AMENDMENTS TO THE DRAWINGS:

REMARKS

10 Application No.: 10/569,553

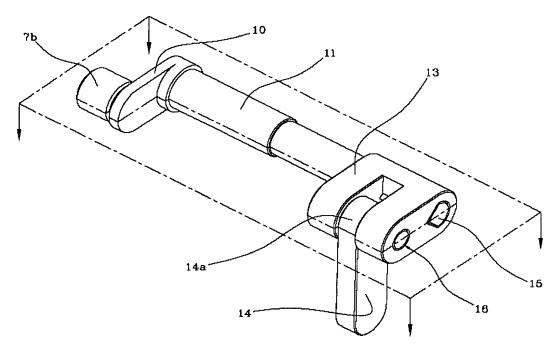
Claims 4 and 5 were rejected under 35 U.S.C. §112, second paragraph, as

being indefinite for failing to particularly point out and distinctly claim the subject

matter which applicant regards as the invention.

The Applicants respectfully submit that, from "Merriam Webster" dictionary, a fork is an element which is divided into branches.

In order to put in evidence the meaning of the expression "fork-shaped" used in the present application, the following explanatory figure has been drawn:

This figure shows a perspective view of the crank mechanism, and in

particular it shows the cam follower 7b, the first crank 10, the shaft 11, the key 15, the second crank 13, the first end 14a of the connecting control rod 14 and the first pin 16. It is evident from the figure the "crankshaft" shape of the shaft.

The figure above appended identifies a plane (in dashed line) in respect of which the section view of Figure 4 of the application has been correctly drawn. The arrows indicate the direction of view corresponding to Figure 4 of the application.

Thus, from figure 4 of the application as filed, it is clear that the end of the second crank 13 is fork-shaped.
